### Area Walk-By Checklist (AWC)

Location (Bldg, Elev, Room/Area): AWC-U2-21

20120809-QuadCities-2 293

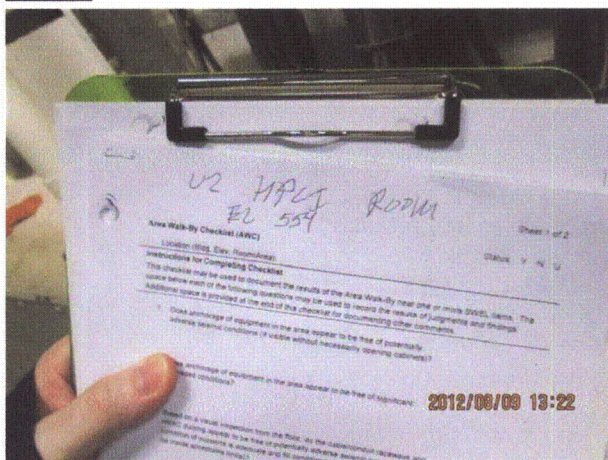
2. Does anchorage of equipment in the area appear to be free of significant degraded conditions? Yes  
*Minor corrosion judged to be acceptable. Grout pads with corners chipped judged to be acceptable.*

4. Does it appear that the area is free of potentially adverse seismic spatial interactions with other equipment in the area (e.g., ceiling tiles and lighting)? Yes  
*Tubes, pipes, and conduits in contact in a number of locations. Judged to be acceptable due to inherent flexibility of the items.*  
*Several overhead light fixtures with open S-hooks. See IR 1400098.*
  5. Does it appear that the area is free of potentially adverse seismic interactions that could cause flooding or spray in the area? Yes  
*Threaded fire piping, room heater, and associated piping well-supported. Other piping welded.*

6. Does it appear that the area is free of potentially adverse seismic interactions that could cause a fire in the area? Yes  
*Metal oily rag bin with cover judged to be acceptable.*

7. Does it appear that the area is free of potentially adverse seismic interactions associated with housekeeping practices, storage of portable equipment, and temporary installations (e.g., scaffolding, lead shielding)? Yes  
*Storage issue corrected during walkdown. See IR 1400948.*
-

20120810-QuadCities-2 209

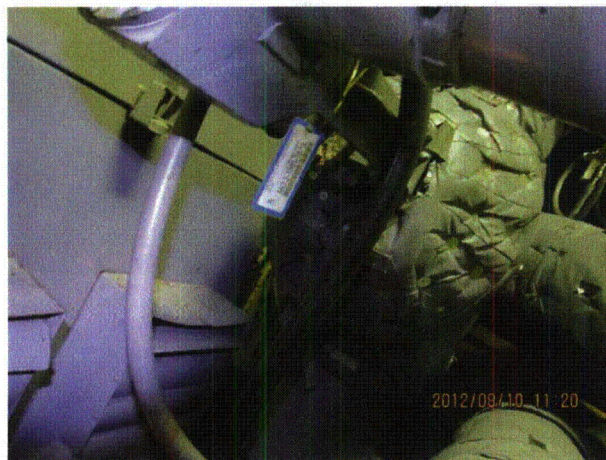
*Room cooler outlets (louvers) with bent sheet metal not affecting operation; not a seismic concern.*

*Minor damage to pipe insulation not a seismic concern.*

*Chemical deposits on one bolt for valve stem on Valve 2-1001-187A-MO. Bolt not more than surface-corroded; judged to be acceptable.*
